Diesel Exhaust Fluid (DEF) Pressure Line Disconnected at the Doser Connection

49-040

Freightliner
Service Bulletin

Fig. 1, Broken DEF Line

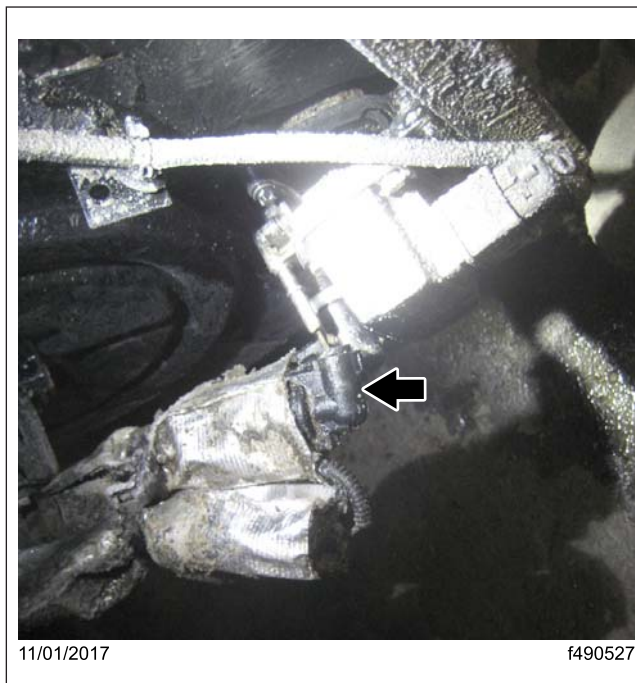
On some GHG14 and GHG17 vehicles equipped with a Detroit one-box aftertreatment system (ATS), the DEF pressure line may be pushed off the doser connection by frozen DEF in extreme cold climates. See [Fig. 1](#). Going forward, vehicles equipped with a Detroit Diesel one-box ATS will have a zip tie installed through the doser mounting bracket and around the DEF pressure line.

Installing the zip tie (part number 23-09796-509) prevents the DEF pressure line from being pushed off. The zip tie can be installed as a preventive measure or can be installed after the DEF line is disconnected, without replacing the DEF line.

Fig. 2, Installing a Zip Tie on the DEF Pressure Line and Doser

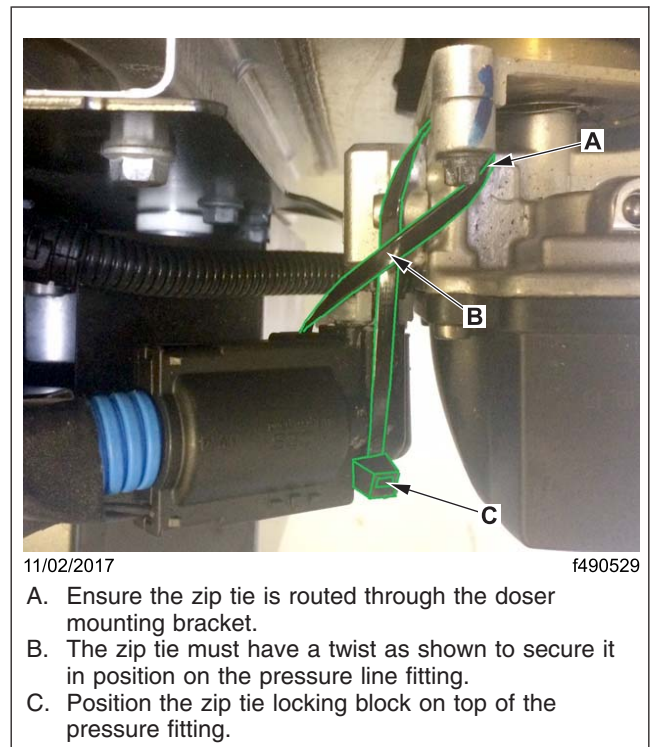
1. Park the vehicle on a level surface, shut down the engine, and set the parking brake. Chock the tires.
2. Locate the DEF pressure line on the ATS.
3. Install a zip tie through the doser mounting bracket and around the DEF pressure line as shown in [Fig. 2](#).
